Response to Submissions

Ivanhoe Estate
SSD17_8707

Submitted to Department of Planning and
Environment
On behalf of Aspire Consortium

27 September 2018 | 17156

Figure 1 Building separation to 137-143 Herring Road

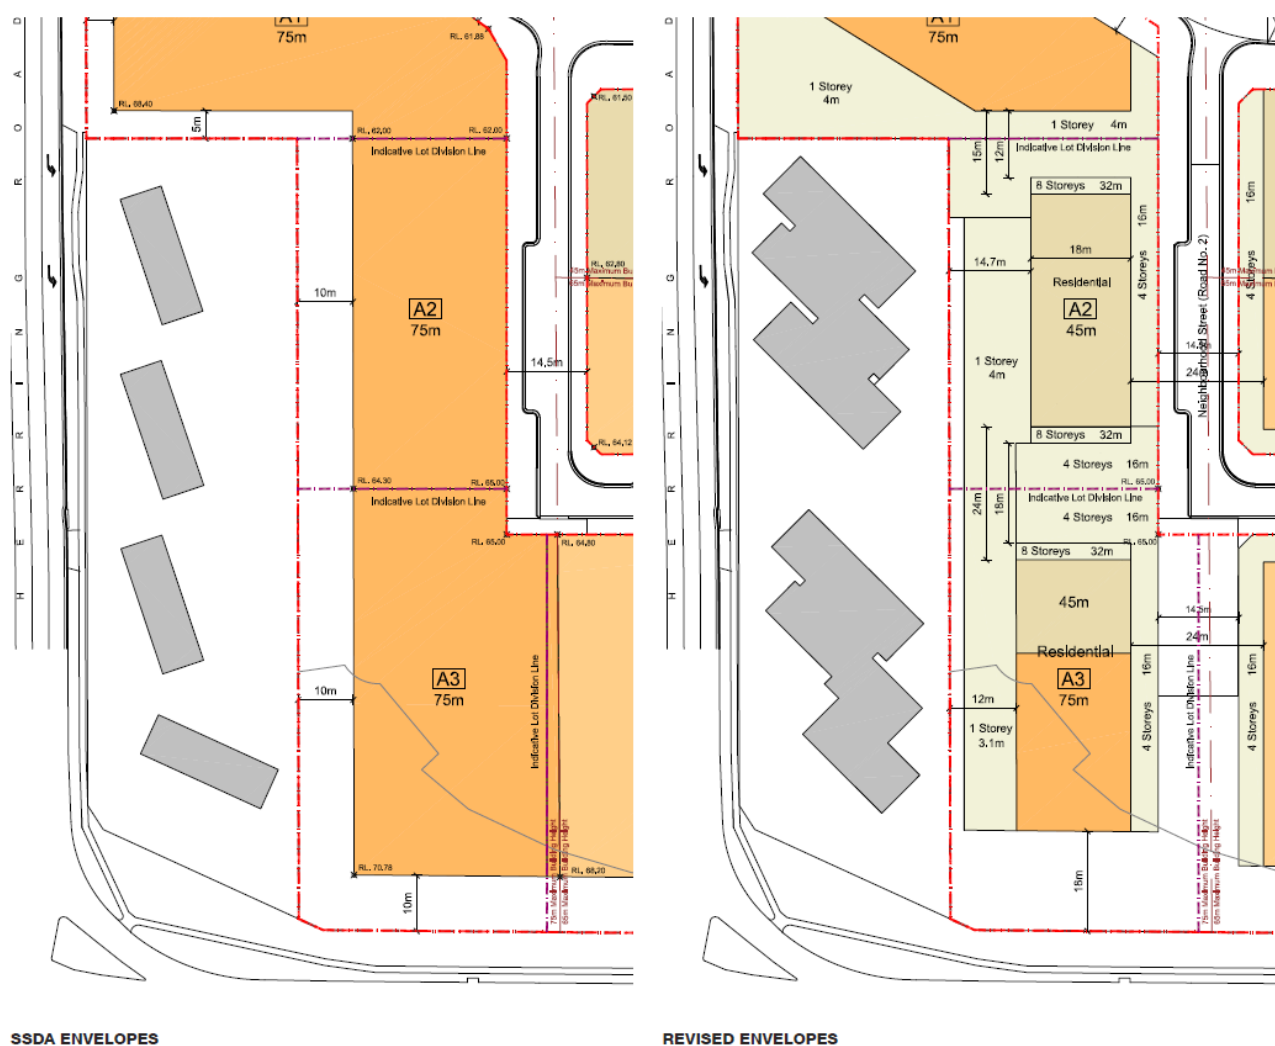
Key changes to the Masterplan have been made to improve the interface to adjoining properties, in particular to the future development at 137-143 Herring Road and existing properties on Peach Tree Road and Epping Road.

Development for the purposes of two residential apartment buildings at 137-143 Herring Road, Epping was approved by the Sydney North Planning Panel on 16 February 2018, following lodgement of the Ivanhoe Estate Masterplan Concept SSD DA. The approved DA includes buildings set back less than the minimum separation in the Apartment Design Guide from the common boundary with the Ivanhoe Estate. A condition of consent requires the apartments to have additional privacy screening along the Ivanhoe Estate boundary and the apartments have been orientated to avoid direct overlooking. However, because of the reduced setbacks within the approved DA site, the future development within the Ivanhoe Estate was adversely impacted.

The Masterplan, as proposed to be amended, has taken into consideration the approved development on the adjoining site and made a number of changes to reduce the impacts of the development which have been created by the non-compliances approved at 137-143 Herring Road. As shown in **Figure 1**, the changes include:

- Building A3 will provide a 12m setback to the boundary within the Ivanhoe Site, consistent with the ADG. The setback results in a total separation of 16.7m at the narrowest point and 24.4m at the widest, despite the approved development only providing a minimum of 4.7m within its site. The proposed separation is close to the minimum 18m separation in the ADG for a habitable room facing a non-habitable room and allows for the privacy at the closest points to be managed through the detailed design phase to ensure appropriate privacy is achieved.

- Building A3's setback to Epping Road has been increased from 10m to 18m, improving the outlook of apartments in the southern building and allowing for the conservation of additional trees, which are part of the endangered ecological community on the site.

- The Total GFA in A2 and A3 has been reduced by approximately 5,800m².

Figure 3 Revised Epping Road setback

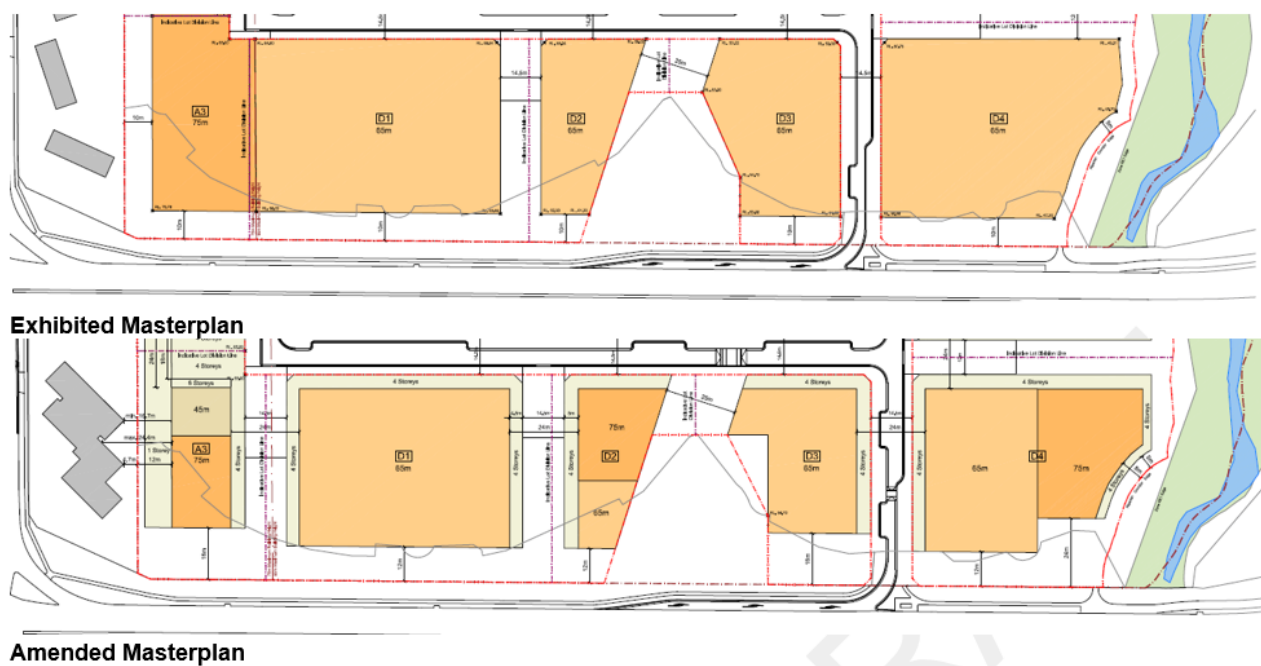
No submissions were received that identified themselves as residents of Epping Road properties, however additional consideration has been given to the impact on these properties in response to the Department of Planning and Environment's feedback. The following changes have been incorporated to improve the relationship to Epping Road properties:

- The setback on Epping Road has been increased from 10 metres to a minimum of 12 metres, allowing for the retention of additional vegetation. This setback also increases to 18 metres for buildings A3 and D3 and 24 metres adjacent to the Shrimptons Creek riparian corridor. This increased setback allows for increased retention of trees to provide a greater vegetated buffer to properties on the opposite side of Epping Road.
- The D2, D3 and D4 building envelopes have been refined to modulate building mass, locating wider parts of the floorplate in the centre of the site and reducing the perception of the bulk when viewed from Epping Road.

A comparison of the refined Epping Road interface is illustrated at **Figure 3**.

Figure 4 Revised riparian corridor
Source: Bates Smart

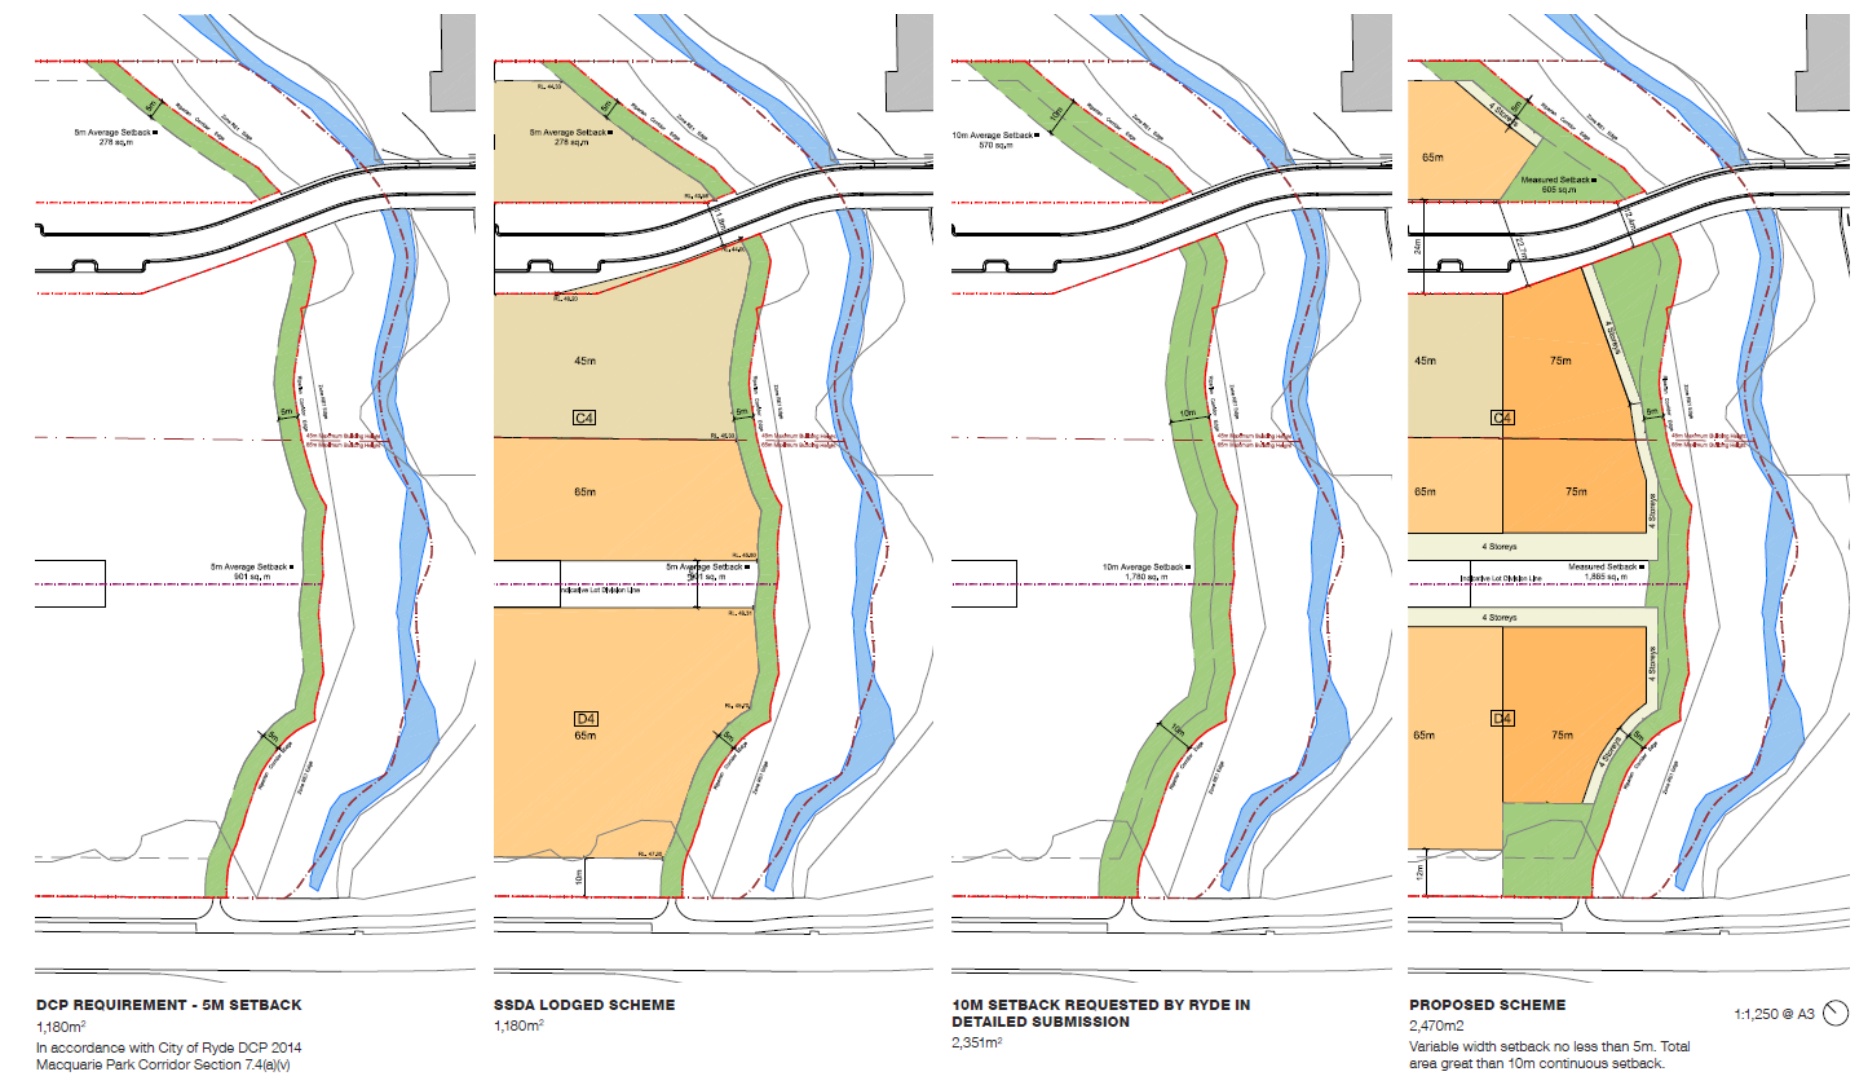
Shrimptons Creek Riparian Buffer

An enhanced riparian buffer has been incorporated into the refined Masterplan. The exhibited design proposed a 20 metre riparian corridor adjoining Shrimptons Creek in accordance with the NSW Office of Water *Guidelines for riparian corridors on waterfront land* and this buffer has been expanded through the incorporation of increased setbacks from the edge of the riparian corridor and additional 'forest threshold' green spaces along the creek. The buildings adjoining the creek are set back at least 5 metres, in accordance with the RDCP, and this setback area has been increased through refinement and reorientation of the building envelopes. The proposed riparian corridor and buffer area comprises a total of 2,470m², which is larger than the buffer that would be provided if the 10 metre setback recommended by Council was adopted. The proposed riparian buffer is illustrated at **Figure 4**.

Figure 14 Revised interface to Peach Tree Road

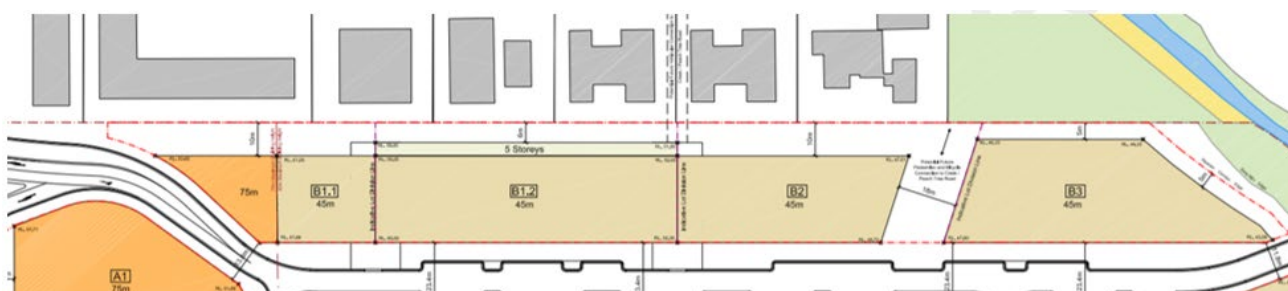
A number of submissions were received from landowners in apartments fronting Peach Tree Road, concerned about the general loss of amenity as a result of the development. A detailed response to the specific issues raised by the residents is provided at **Appendix B**. In response to the concerns raised by the residents, a number of refinements have been made to the Masterplan along the Peach Tree Road boundary (see **Figure 2**). The changes include:

The refined Masterplan clarifies that upper level setbacks to the Peach Tree Road boundary will be a minimum of 12 metres, in accordance with the ADG. This is illustrated at **Figure 14**.
